## DPR 25-12: Park Place Crossing – 56-108 Park Place Boulevard (approx. address)

Planning & Building Department Staff Report

For Hearing on February 23, 2026

<b>A. PETITION NUMBER</b>	DPR 25-12: 267 Park Place Crossing
<b>B. APPLICANT</b>	Tranquility, LLC, by Kruse Consulting, Inc.
<b>C. LOCATION</b>	56, 82, & 108 Park Place Boulevard (approximate addresses)  Lots 5, 6, & 7 in Avon Park Place
<b>D. PARCEL SIZE</b>	1.68 acres
<b>E. LAND USE &amp; ZONING</b>	The site is undeveloped, is zoned C-2: General Commercial District, and located within Tiers 1 & 2 of the U.S. Highway 36 Zoning Overlay.
<b>F. ACTION REQUESTED</b>	Request for approval of a Development Plan Review to allow for construction of a one-story, multi-tenant commercial building with surface parking and related improvements.
<b>G. HISTORY</b>	<p>The site was platted and recorded in 1988 under the jurisdiction of Hendricks County.</p> <p>This petition was discussed at the September 18, 2025 Technical Advisory Committee (TAC) meeting, and accordingly docketed for the October 27, 2025 Plan Commission (PC) meeting. The petition was continued to the December 22, 2025 meeting, and then to the January 26, 2026 hearing to a

## Exhibit B – Proposed Site Plan

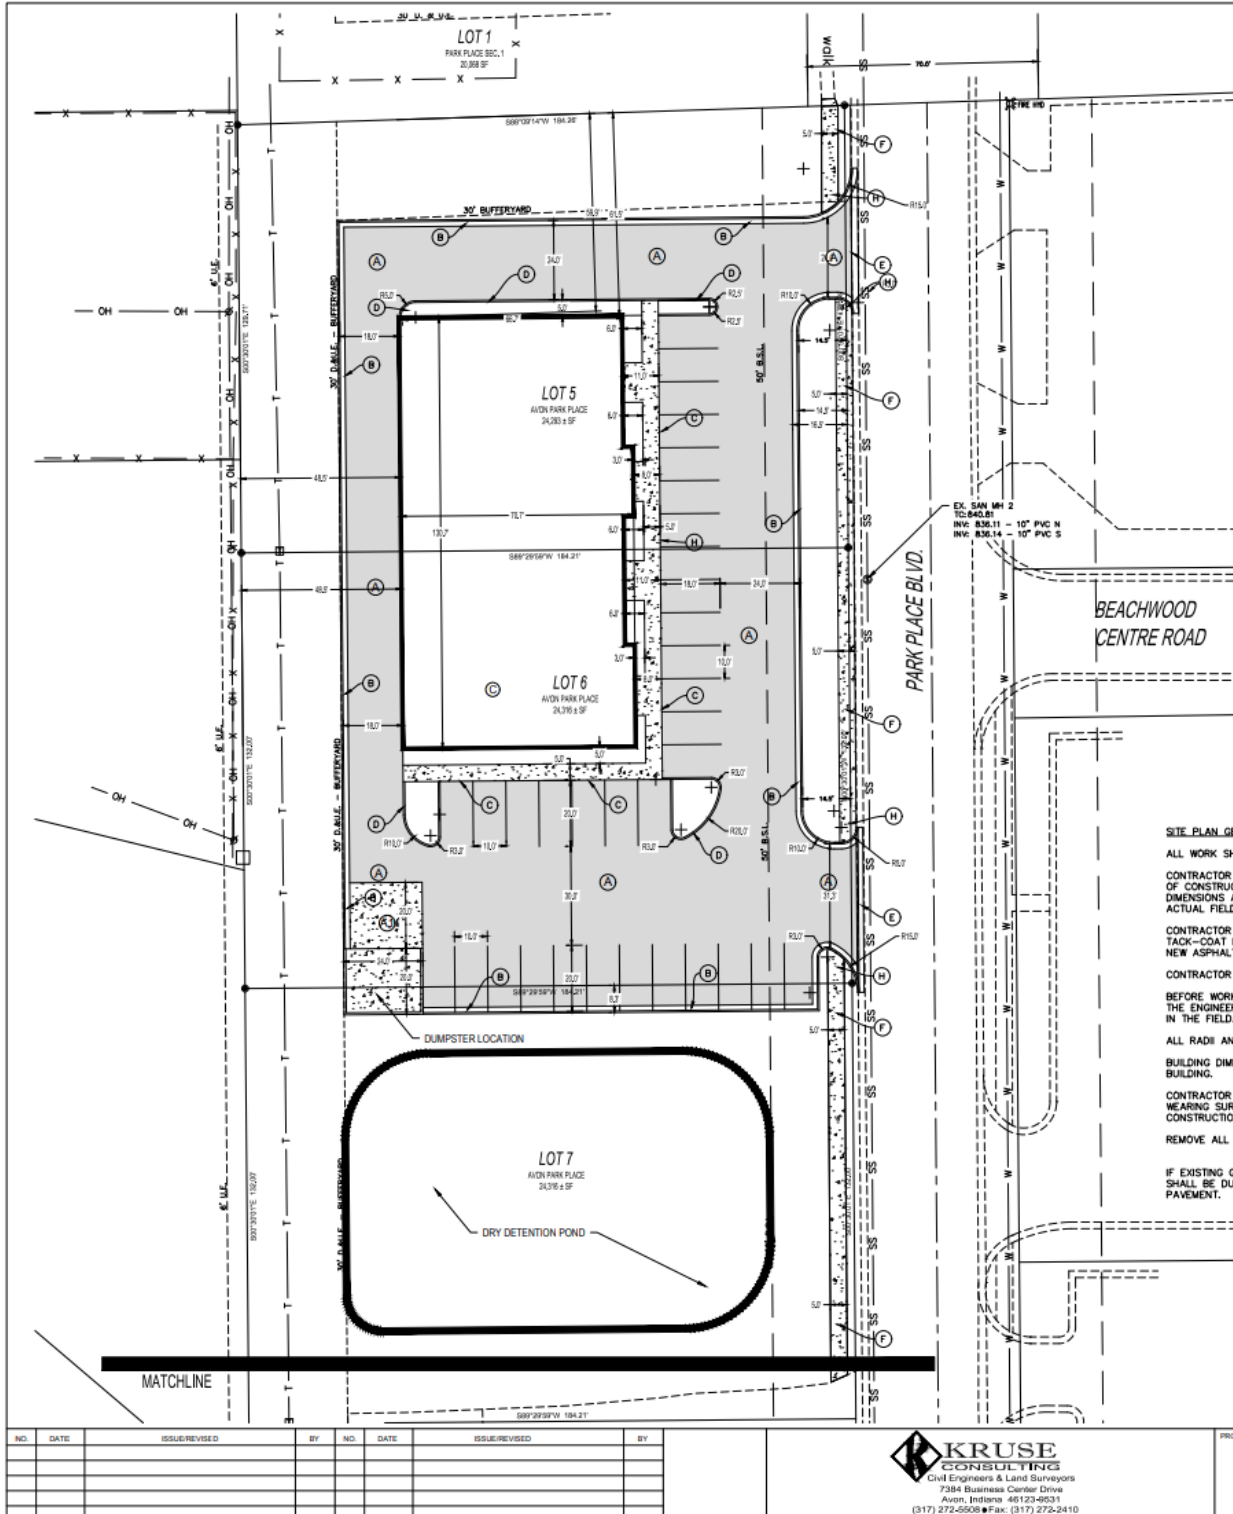
2. Per comments from the Department of Public Works and UDO 2.10(L), an extension of the business collector street (Beechwood Centre Road) identified in the Town of Avon Thoroughfare Plan must be constructed with development of this site. The site plan will need to be revised to relocate the proposed improvements to accommodate said street extension.

7. Per UDO 2.10(M)(1), a minimum 20' deep front yard landscape buffer is required. The submitted plans are deficient. Please revise plans accordingly or request a variance or waiver (if eligible).

8. Per UDO 6.6(C), one parkway tree is required to be planted in the right-of-way per 50 lineal feet of frontage. No parkway trees are indicated on the submitted landscape plan. Please revise the landscape plan accordingly.

9. Per UDO 2.10(M)(4) & UDO 6.7(C), two (2) shade trees per seventy feet of lineal feet of parking lot perimeter are required. This appears to require four trees along the east perimeter and six along the west perimeter, where only three and four respectively are shown on the landscape plan. Please revise the landscape plan accordingly.

10. Per UDO 6.7(C)(2)(b), a continuous dense hedge running the length of the parking lot is required abutting the west and north perimeters of the lot, and covering 75% of the east and south perimeters of the lot. Please revise the landscape plan accordingly.

11. Per UDO 6.8(D), a solid, year-round screen at least 8 feet high is required within the north and west buffer yards. A 6-foot high shadow box fence is proposed on the landscape plan. Please revise plans to indicate compliance with one or more of the options listed in UDO 6.8(D).

12. Per UDO Table 6.1, 90-degree angle parking requires 20-foot deep spaces, however, 18-foot deep spaces are shown in one of the rows. A variance or waiver can be requested, or the plans will need to be revised accordingly.

13. The application indicates that the building would be used for "office flex space". The closest match to this for purpose of parking requirements in UDO Table 6.3 would be "Office, All Others", which requires 2 spaces per 1,000 square feet of gross floor area, which would require 49 parking spaces for the proposed 24,293 square-foot building. Only 33 spaces are shown on the proposed plan. A variance or waiver can be requested or the plans will need to be revised accordingly, unless the proposed use of the building is revised.

14. Per UDO Table 6.5, one loading space would be required, which would need to be a minimum dimension of 12 feet by 30 feet, unless tractor-trailers would be servicing the site, and would need to meet the standards in UDO 6.13(C). Please revise plans accordingly.

15. Per UDO Table 6.4, a development providing parking spaces within a range of 26 to 50 must provide a minimum of two (2) accessible parking spaces meeting the standards of UDO 6.12(E). No such spaces appear to be indicated on the plans. Please revise the plans accordingly.

16. Per UDO 6.11(F), wheel stops are required adjacent to pedestrian walkways. Please revise plans accordingly.
17. Per UDO 6.11(G), all rows of parking must have terminal islands with a minimum width of eight (8) feet and a minimum area of 130 square feet. The terminal island at the north end of the parking in front of the building appears to measure ~ five (5) feet wide and ~ ninety square feet. Please revise plans accordingly.

18. Per UDO 6.11(D)(3), the first twenty (20) feet of a drive must be kept free from parking maneuvers. The parking space at the southeast corner of the site would violate this requirement. Please revise plans accordingly.

19. Per UDO 6.5(A), a minimum five (5)-foot wide landscaped strip is required around the perimeter of all principal buildings exclusive of doorways and loading areas. The west façade and portions of the east façade do not appear to meet this requirement. Please revise plans accordingly.

## Exhibit B2 – Revised Site Plan (6-Feb-2026)

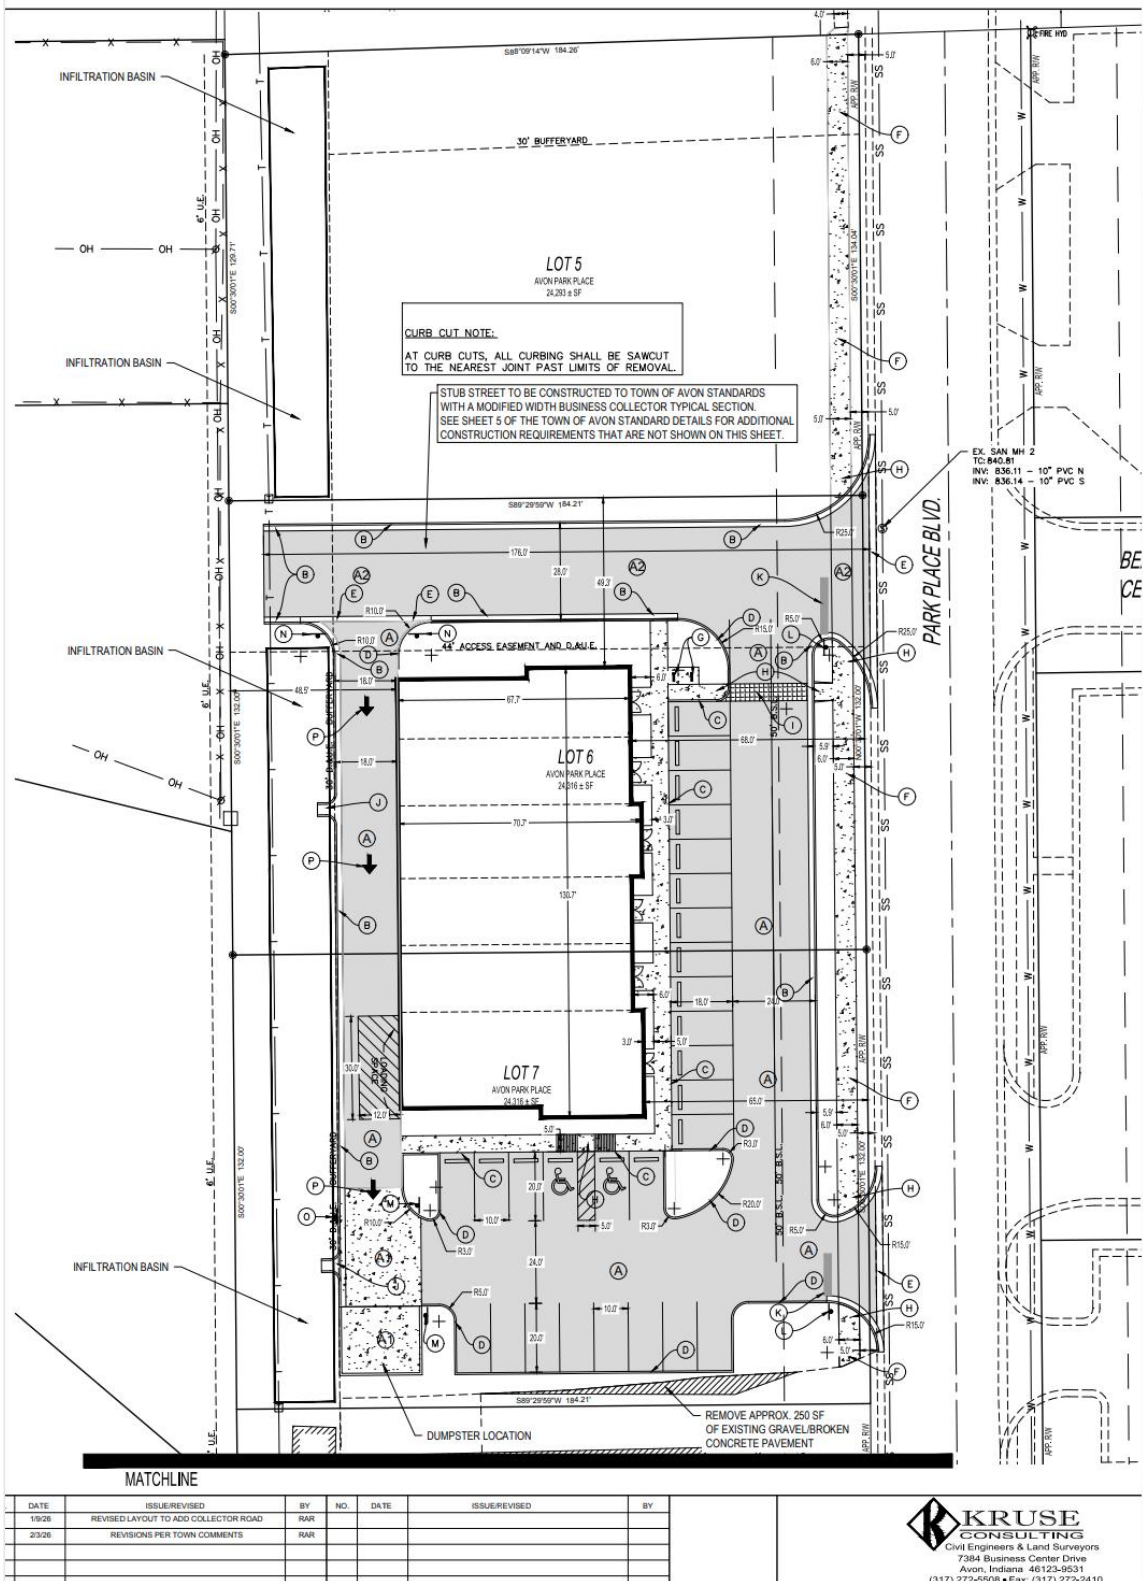
Waiver: A waiver of development standards of UDO 2.10(L), to construct a 28-foot wide private access road within a 44-foot wide access easement in lieu of constructing a public street extension of Beechwood Centre Road with a 36-foot wide street and 5-foot wide sidewalks within a 60-foot wide public right-of-way (construction to public street standards required).

Waiver: A waiver of development standards of UDO Table 6.1 to provide for a row of 18-foot deep off-street parking spaces (minimum 20-foot parking space depth required).

Waiver: A waiver of design standards of UDO 7.21(E) to provide for a full-access driveway onto Park Place Boulevard offset from two existing driveways on the opposite side of the street (minimum 150-foot separation required).

Staff concurs with the petitioner's response. The proposed pavement width and easement (or right-of-way) width would be adequate to provide for future traffic needs.

**Staff recommends approval of this waiver request.**

**Staff concurs with the petitioner's response. A 10' x 18' parking space with a 24' two-way drive aisle will provide adequate maneuvering for drivers visiting an office development that typically has lower parking lot turnover than many other retail commercial uses.**

**Staff recommends approval of this waiver request.**

**Staff recommends approval of this waiver request.**

# Exhibit B3 – Revised Landscape Plan (6-Feb-2026)

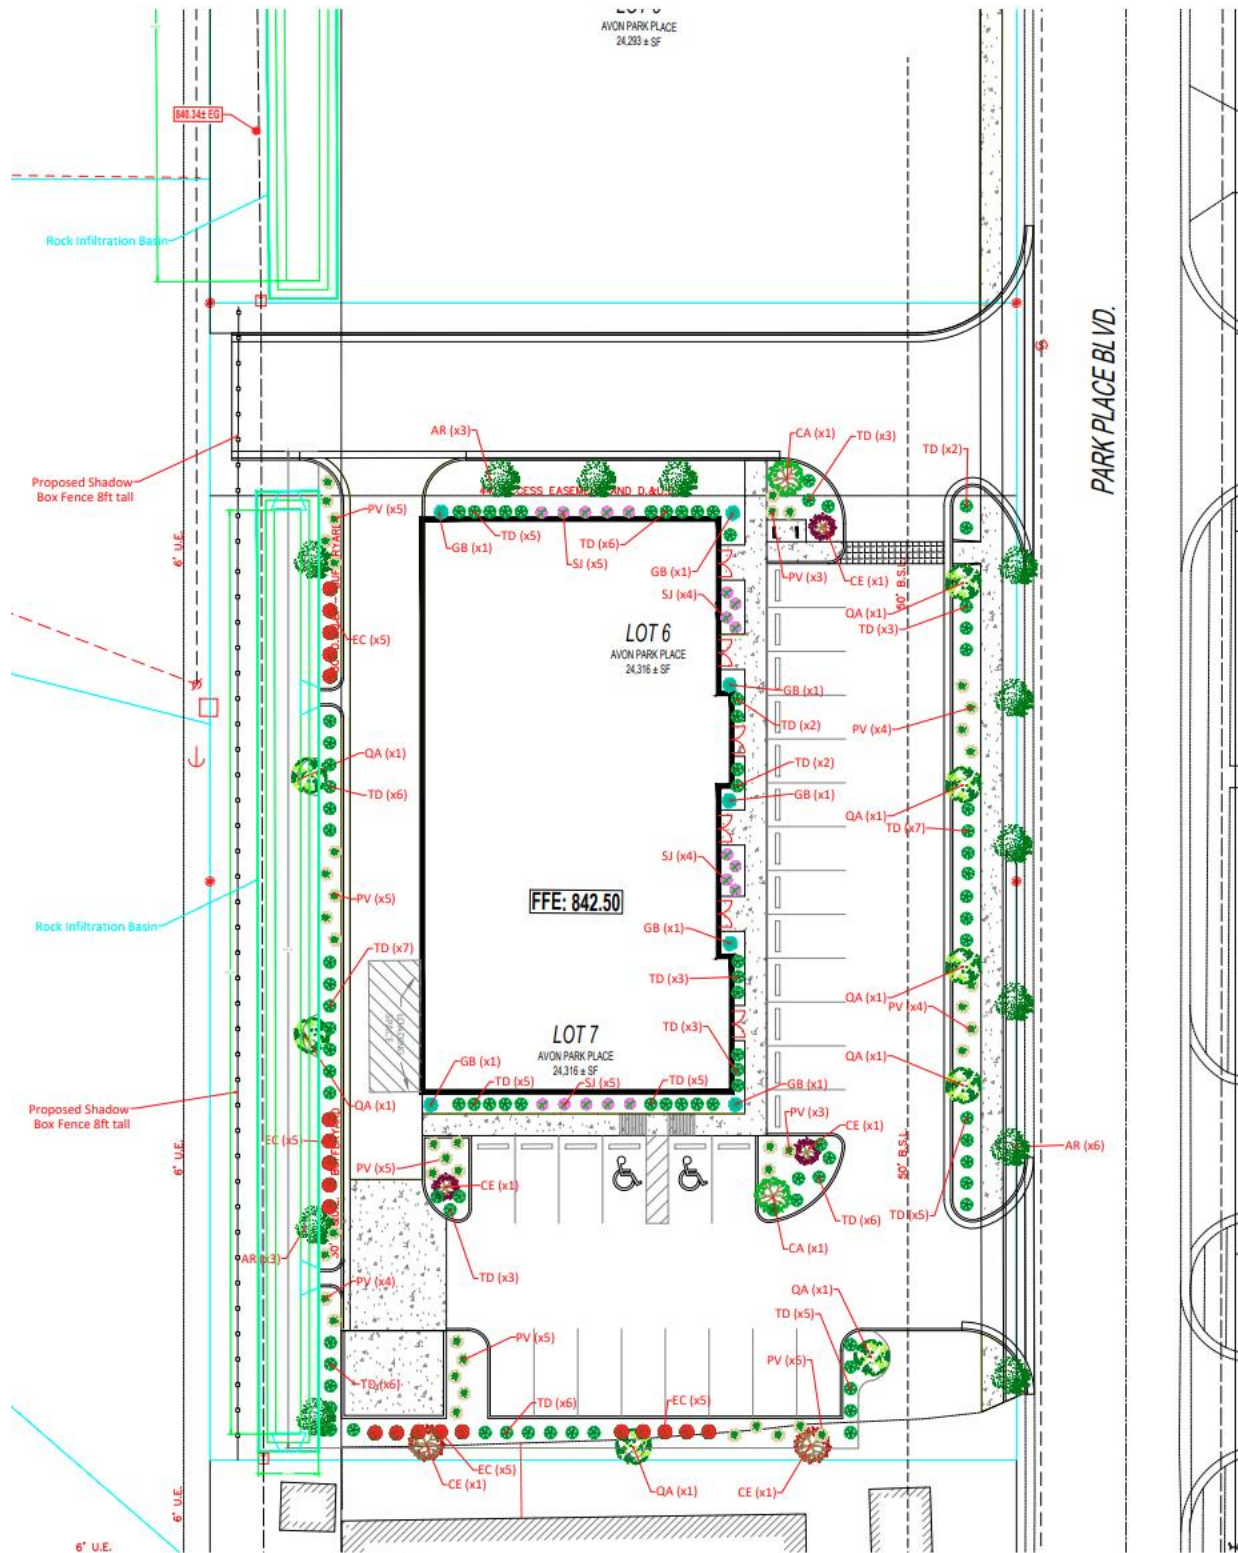
Waiver: A waiver of development standards of UDO 2.10(M)(1) to provide for a 16.9-foot front landscape buffer with sidewalk therein (minimum 20-foot front landscape buffer required).

Waiver: A waiver of development standards of UDO 6.5(A) to provide for no foundation planting area adjacent to the west façade and a reduced width of foundation planting area along portions of the east façade (minimum 5-foot wide planting area required around the building except at loading areas and doorways);

Staff concurs with the petitioner’s response. The request is a minor deviation from the standard and will not preclude meeting the overall required number and type of landscape plantings.

**Staff recommends approval of this waiver request.**

**Staff recommends approval of this waiver request.**
